# Enlarged Top Plate Openings

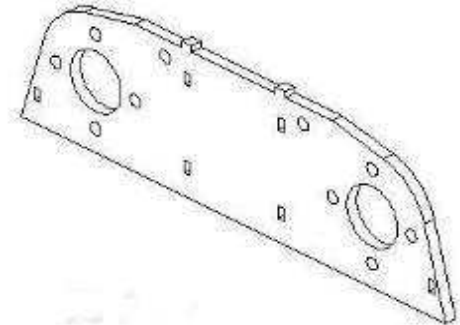
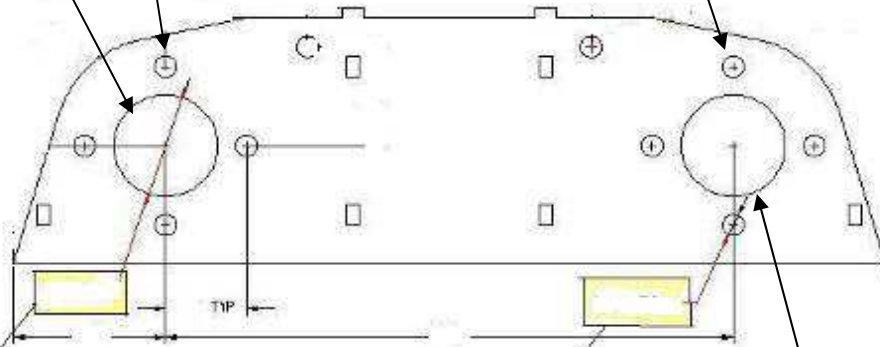
These dimensions allow the bearing buddy assembly space so that the lower spindle end will line up the bushing in the lower dogbone plate with less chance of binding

Stud Opening:  
Was: 17/32"  
Now: 9/16"

The only changes are the dimensions in the rectangular boxes

Spindle Opening:  
Was: 2-9/16"  
Now: 2-19/32"

**Enlarging openings should be done as required by die grinding (machining not practical)**  
Recommend dropping in a new spindle assembly, if the flange doesn't drop all the way to the mounting base without forcing it, THEN make all the openings larger to the new sizes shown.
